Subject: Response to NRC Request for Additional Information for the
Review of the Fermi 2 License Renewal Application – Sets 23, 24, and 26

**Enclosure 1 to
NRC-15-0031**

**DTE Response to NRC Request for Additional Information for the
Review of the Fermi 2 License Renewal Application – Sets 23, 24, and 26**

Figure 1:
%B4C LOSS VERSUS AREAL B-10 DENSITY

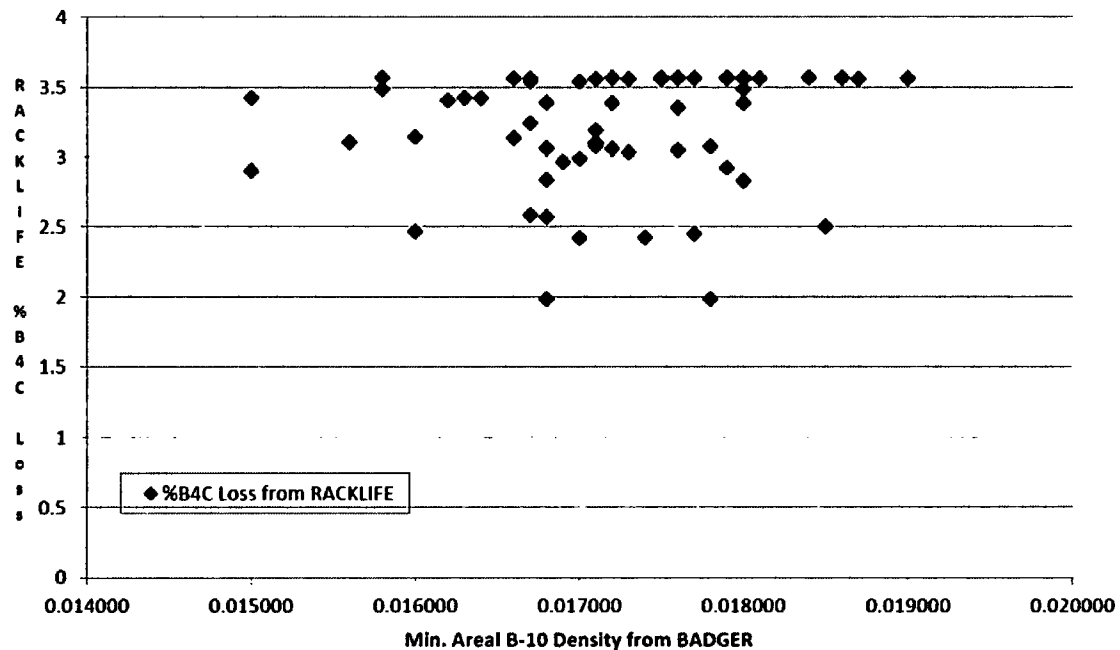
- 2. On page 8 of Enclosure 2 to NRC-15-0008, it states that a RACKLIFE model of the Fermi 2 racks is used to estimate the service history of each Boraflex panel, specifically estimated gamma exposure. The license renewal application further states that the RACKLIFE model is used to calculate the amount of boron carbide loss from the Boraflex panels. Please discuss how the RACKLIFE model predictions compare with the results of the 2013 BADGER test report.*

When comparing % B_4C loss from RACKLIFE to minimum areal density (AD) from BADGER there does not appear to be a correlation (refer to Figure 1 on the following page). An analysis of the BADGER 2013 data using Minitab resulted in a Pearson correlation coefficient of 0.130. The Pearson correlation coefficient can range from -1 (for a strong negative correlation) to +1 (for a strong positive correlation). A value equal to zero yields no correlation. Laerd Statistics (www.statistics.laerd.com) has proposed the following guidelines for interpreting the Pearson correlation coefficient:

Hence, a correlation coefficient of 0.130 shows the strength of association to be small.

The reasons for this are that RACKLIFE calculates loss from an initial panel state (volumetric density and thickness). The initial panel data for each panel was not provided by Joseph Oat (the manufacturer of the racks). A calculation of % loss isn't particularly useful for purposes of comparison to a criticality analysis unless one knows the starting point or has a data point. A BADGER test provides that data point from which RACKLIFE can then predict when an areal density will be below the value assumed in the criticality analysis. RACKLIFE uses a common escape coefficient (panel cavity volumes per day) for the whole pool and assumes uniform degradation across the whole panel. There can also be differences between individual panels either from construction anomalies or damage such that the water ingress/egress rate can vary from panel to panel. RACKLIFE and BADGER must be used together to portray an accurate picture of the Boraflex panels.
